Napoleon Power & Light

ITEM 240 ORCHARD LN.

DATE	W.O.#	J.O.#	DRAWN BY
5/18/93	29279	.IN1222

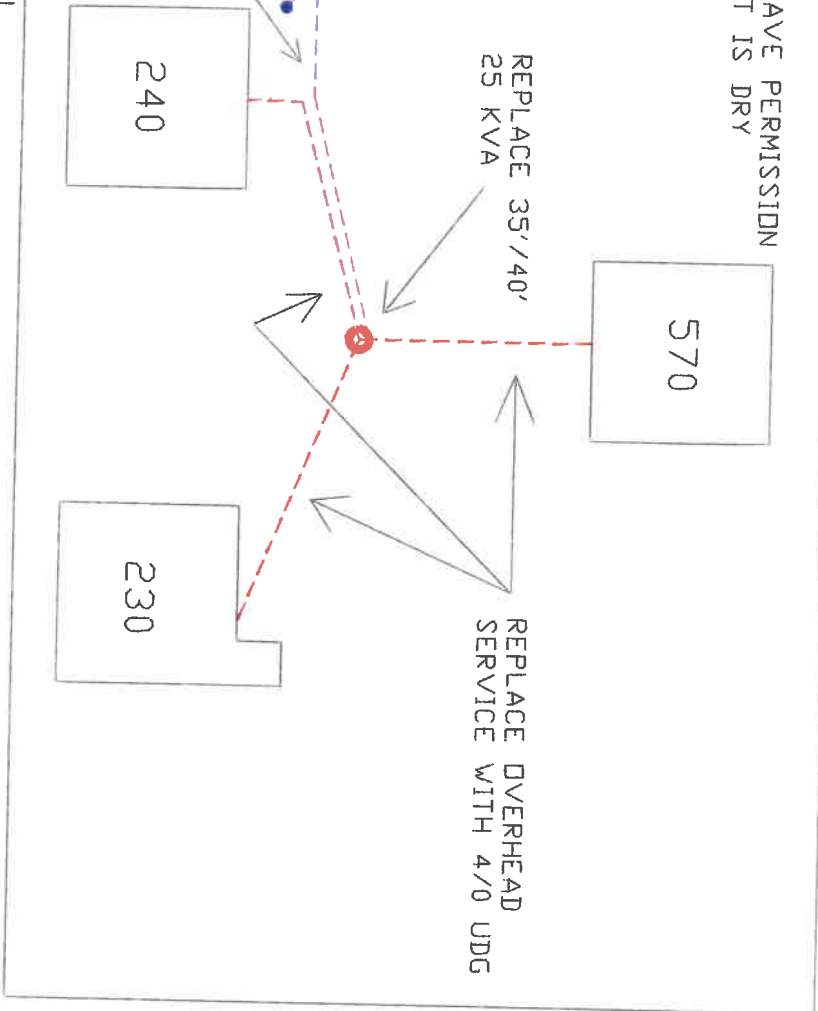
THE MAN AT 570 ROHM GAVE PERMISSION TO GD IN HIS YARD IF IT IS DRY

CHANGE THE ANGLE OF THE LIGHT TO FACE THE BACK OF THE HOUSE

REPLACE #6 DUPLEX WITH UDG TO POLE WITH YARD LIGHT

REPLACE 35' / 40' 25 KVA

REPLACE OVERHEAD SERVICE WITH 4/0 UDG
